## 7.0 Instrumentation and Control Systems

### 7.1 Introduction

The information in this section of the reference ABWR DCD, including all subsections and tables, and figures, is incorporated by reference with the following departures and supplements.

Figure 7.1-1 ~~SSLC Self-Test System~~ Diagnosis

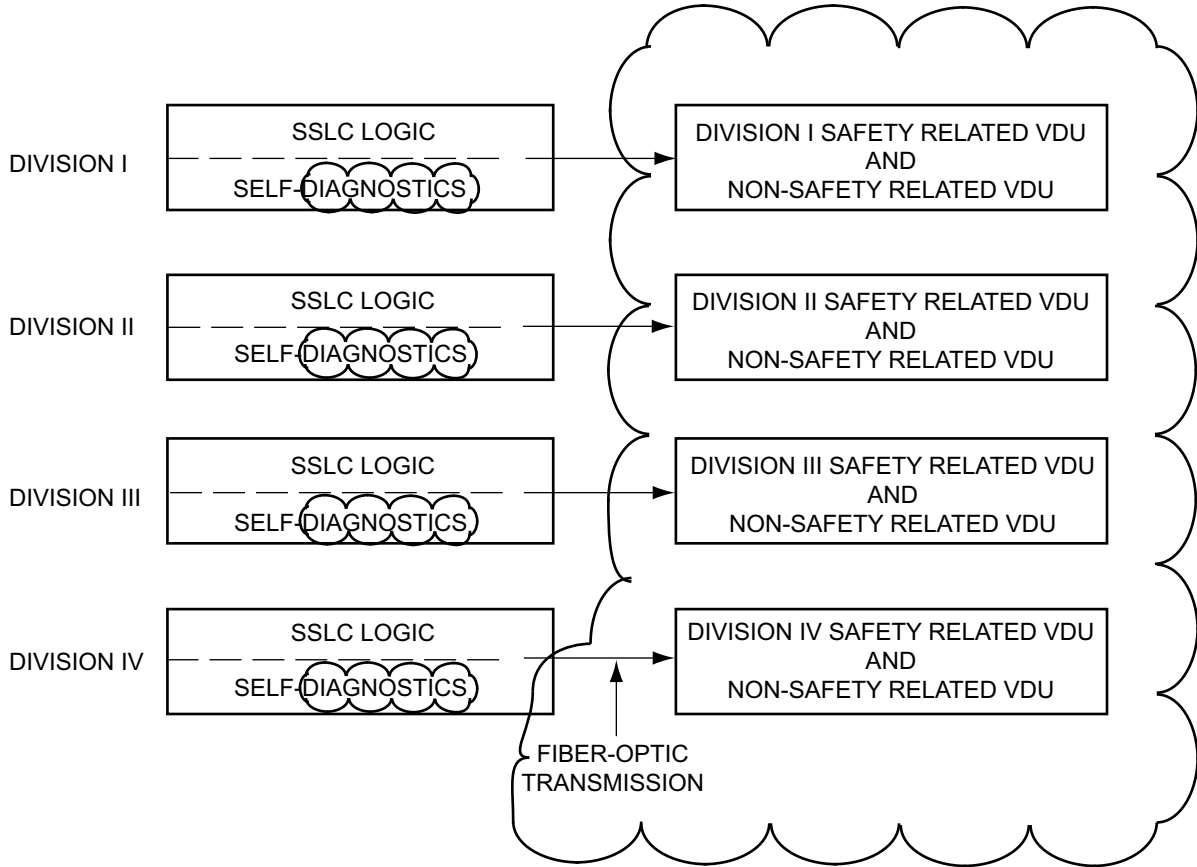
STD DEP T1 3.4-1 (Figure 7.1-1, 7.1-2)

STD DEP T1 3.4-1

**Figure 7.1-2 Assignment of Interfacing Safety System Logic to SSLC Controllers**

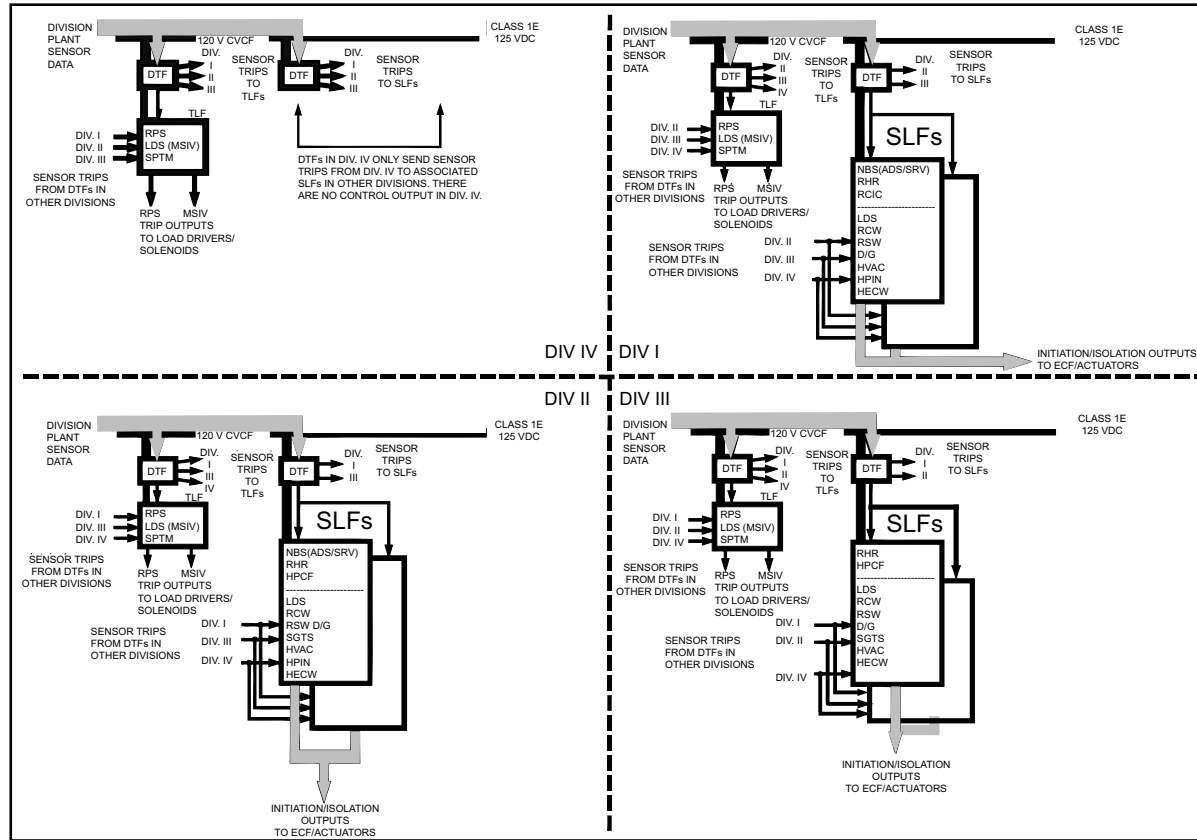
~~Divisional separation is also applied to the essential multiplexing system (EMS) Essential Communication Function (ECF) for Safety System Logic and Control (SSLC), which provides data highways for the sensor input to the logic units and for the logic output to the system actuators (actuated devices such as pump motors and motor-operated valves).~~ Systems which utilize the SSLC are include: (1) Reactor Protection (trip) System; (2) High Pressure Core Flooder System; (3) Residual Heat Removal System; (4) Automatic Depressurization System; (5) Leak Detection and Isolation System; (6) Suppression Temperature Pool Monitoring System; and (7) Reactor Core Isolation Cooling System. The equipment arrangement for these systems and other supporting systems is shown in Figure 7.1-2.
